Hazelwood Rehabilitation Investigation Report

Ref: RPT012

Minister for Resources, Jaala Pulford MP, referred to the Mine Land Rehabilitation Authority (the Authority) on 30 September 2021 five matters for investigation related to rehabilitation planning for Hazelwood mine (Mining Licence Number 5004) in the Latrobe Valley, Victoria. The five matters, published in Government Gazette G.39 comprise:

Figure 2.6 PoF for the 7^o and the 9^o water gradients at RL+8 and RL+25 (Reproduced from Figure 35, GHD (2018))

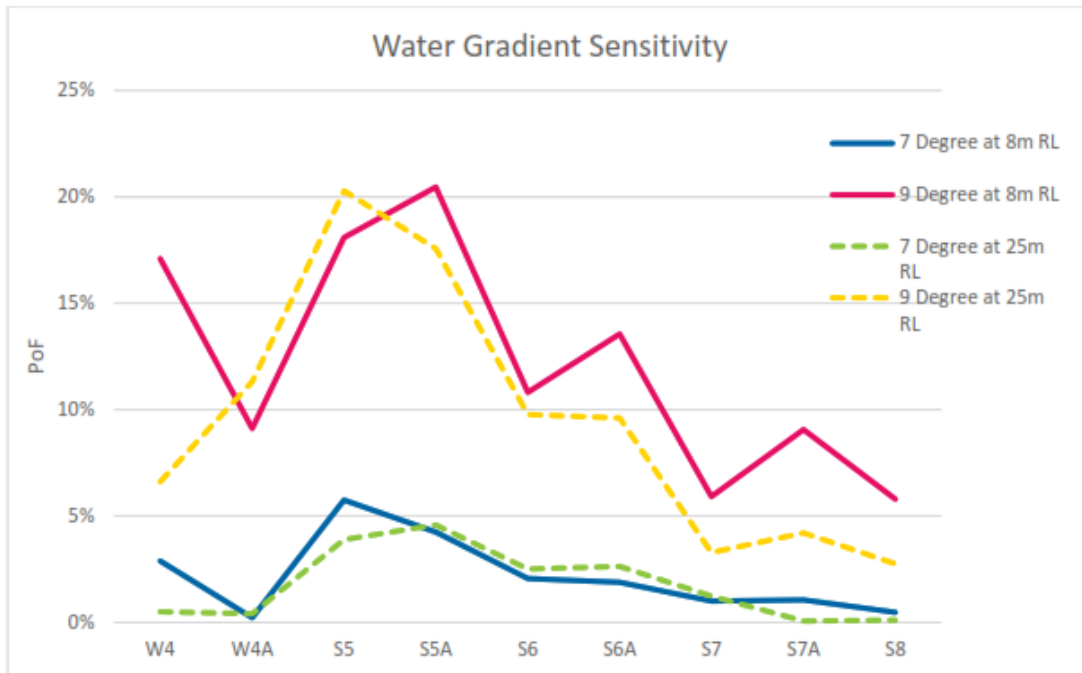
Two aspects of the rehabilitation at Hazelwood suggest that the measure of consequence should be expanded. The first aspect concerns the 'repairability' of a failed batter, particularly when the pit lake water levels are well above mine floor level. A review of the stability sections suggests that in most cases large volume movements would extend under the lake surface. For this case it seems likely that repairs will be difficult and, presumably, costly if the ground is to be stabilised to minimise further movement. If the ground cannot be stabilised cost effectively then an area of the lake perimeter and the ground behind could present higher future ground movement risks, though this would need to be assessed. This would impact potential future land uses.

The second aspect concerns the stress relief that could occur in the ground behind the failure zone. Horizontal and vertical ground movements will be reactivated that could potentially impact sensitive receptors behind the batter. An example would be horizontal strains across the Princes Freeway and the Morwell Main Drain leading to defects in both structures. While the expectation is that the batter designs will minimise the risks of failure, measures of consequence need to be included in such a way that they focus attention on possible long-term impacts and on those areas of the mine where the consequences of a failure are greatest. Consideration of displacement volumes alone does not meet this objective.

Figure 2.8 Comparison of PoF results during lake filling for the East Field Northern Batters (EFNB) and the West Field Southern Batters (WFSB) showing the design acceptance criteria (shaded area)

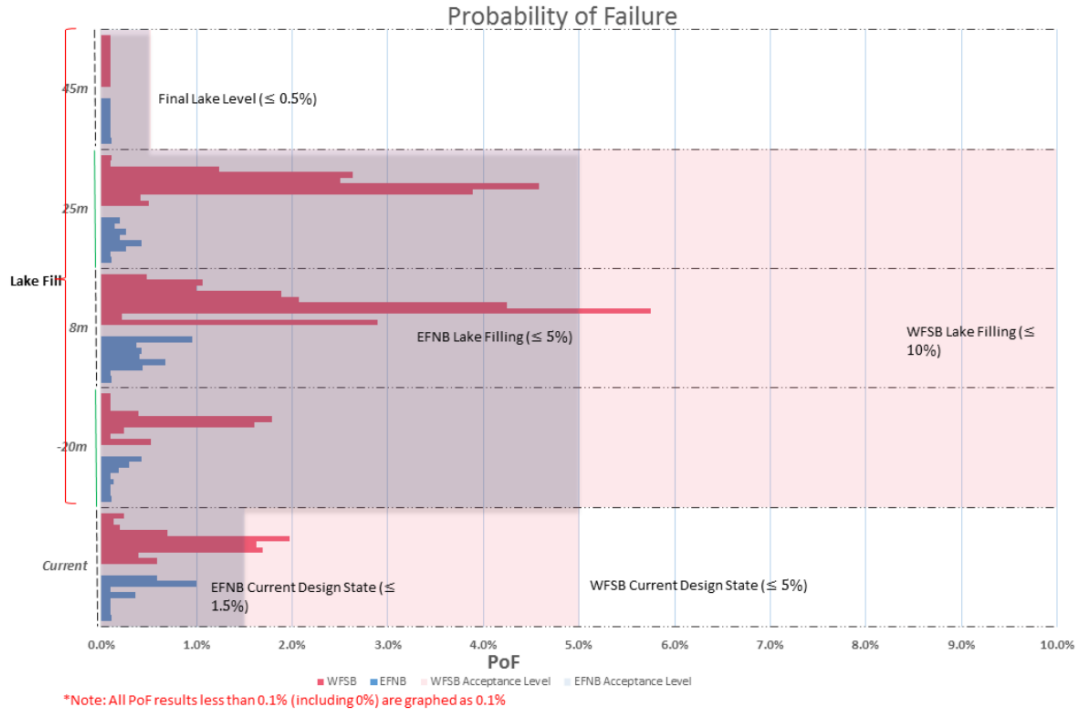
Figure 2.8 illustrates ENGIE’s design acceptance criteria for the East Field Northern Batters and the West Field Southern Batters. Also shown are the assessed PoFs for the base cases for each batter for each representative lake water level.

Design PoF should be based on slope design life, ground controls, and failure consequence. The design acceptance levels presented in Table 6 cover each of these criteria. Design life addresses serviceability. Ground controls are based around monitoring but not actions. Failure consequences are based around public risks but not about risks to the environment or infrastructure. While this table is good as a starting point for establishing design acceptance levels for PoF, additional evidence is required to build confidence in the adopted values.
